SEPTIC OWTS SITE PLAN SEPTIC PLAN, PROFILE & DETAILS ARCHITECTURAL A1.0 SITE PLAN BARN FLOOR PLANS BARN EXTERIOR ELEVATIONS BARN INTERIOR ELEVATIONS CABIN PLANS AND ELEVATIONS BARN AND CABINS REFLECTED CEILING PLANS BARN AND CABINS SECTIONS BARN AND CABINS DETAILS BARN AND CABINS DETAILS SCHEDULES & ENERGY COMPLIANCE STRUCTURAL NOTES AND SPECS PLANS AND DETAILS TIMBER - BARN GEN. NOTES AND AXONOMETRIC TF2 AXONOMETRIC TF3 AXONOMETRIC TF4 AXONOMETRIC EXPLODED TF5 POST PLAN LOFT PLAN TF7 **ROOF PLAN** TF8 SOUTH ELEVATION TF9 WEST ELEVATION TF10 LONGITUDINAL SECTION EXTERIOR BENT SECTION INTERIOR BENT SECTION TF13 BRACES & DETAILS TF14 POST BASE TIMBER - CABIN TEC1 INDEX OF DRAWINGS TFC2 AXONOMETRIC TFC3 DETAILS TFC4 DETAILS TFC5 GENERAL NOTES TFC6 SCHEDULES TFC7 POST PLAN TFC8 ROOF PLAN TFC9 FRONT ELEVATION TFC10 RIGHT ELEVATION TFC11 REAR ELEVATION TFC12 LEFT ELEVATION TFC13 SECTION VIEW TFC14 SECTION VIEW TFC15 PLATES TFC16 TIE BEAM TFC17 KNEE BRACE TFC18 KING POST TFC19 POST A-1

UHL BARN AND CABINS

NO.	ISSUE/REVISION-NAME	DATE
0.0	PERMIT SET	5/24/23
1.0	PERMIT SET COUNTY COMMENTS	7/23/23
·		
	·

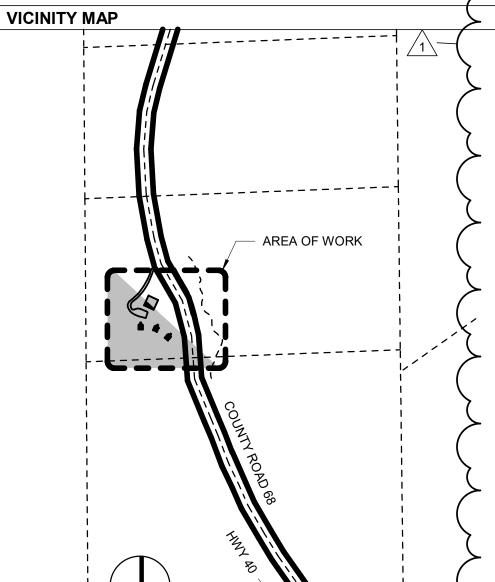
accommodations have to be within one building meaning sleeping

Occupant Load Information Per PL20210018 is as follows:

dwelling, sanitation and cooking would have to be in each building p

Please insert for Occupancy Type the following: Residential Accessory

Three Guest Cabins, each cabin is allowed two guests at a time, fdr a

BARN AND CABINS DETAILS

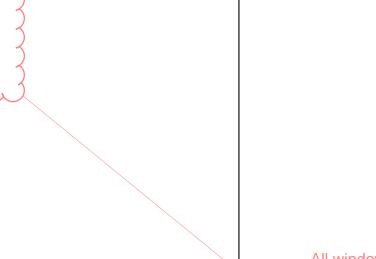
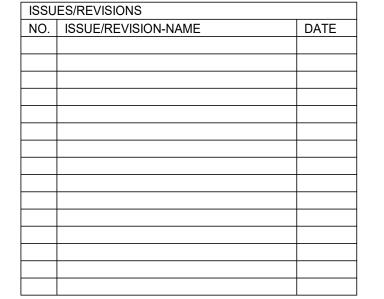
All windows must have a U-factor of .30 or less, please change this on window schedule on sheet A4.0
